RECALL CAMPAIGN BULLETIN

NTB16-052b

VOLUNTARY SAFETY RECALL CAMPAIGN OCCUPANT CLASSIFICATION SYSTEM REPROGRAMMING

APPLIED VEHICLE: 2016 Maxima (A36)
2013-2016 Altima (L33)
2014-2016 Rogue (T32)
2015-2016 Murano (Z52)
2015-2016 Murano Hybrid (Z52)

Front Passenger Air Bag Status Light

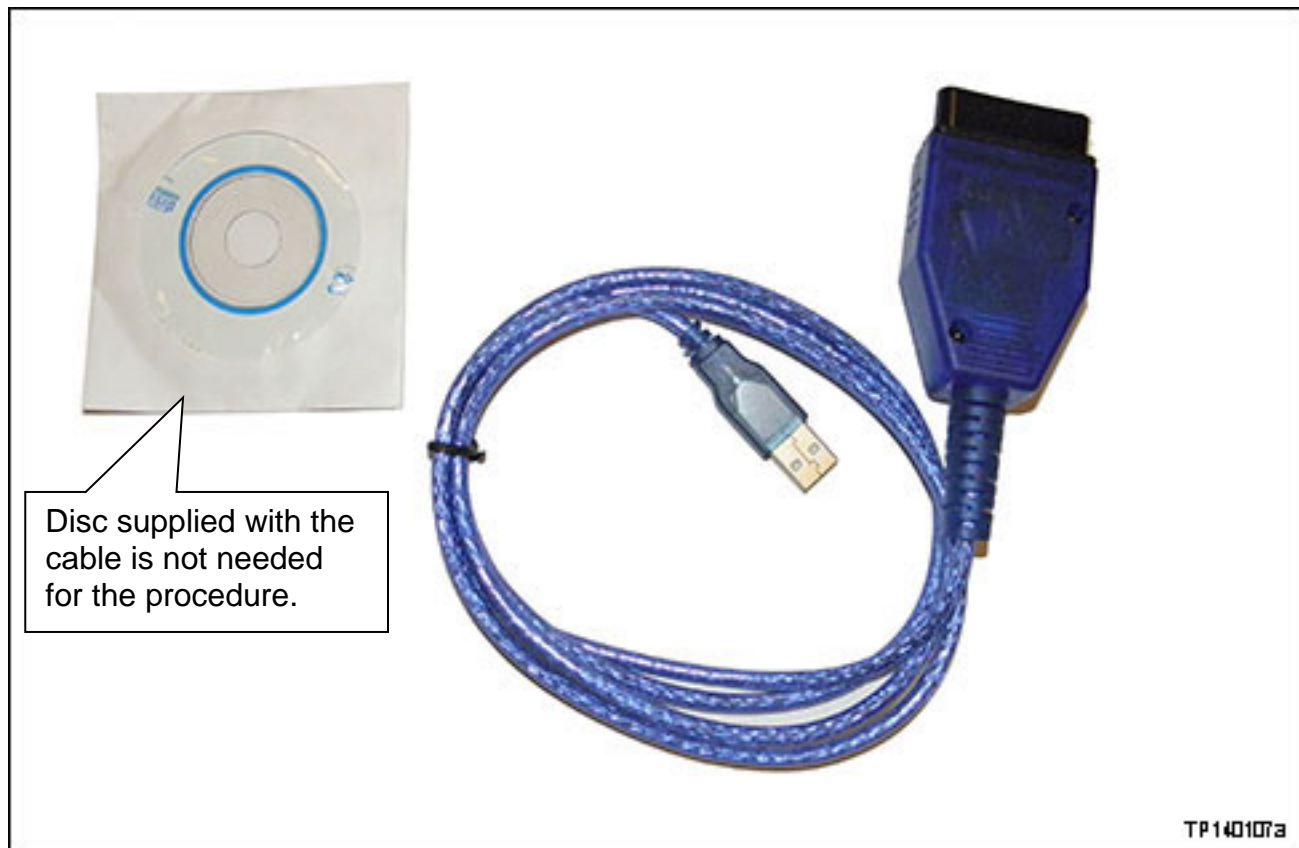
Performing the procedures in the bulletin (campaign R1609) changes the operation of the passenger air bag status light.

- After performing this campaign, the passenger air bag status light will be ON (illuminated) when the front passenger seat is empty.
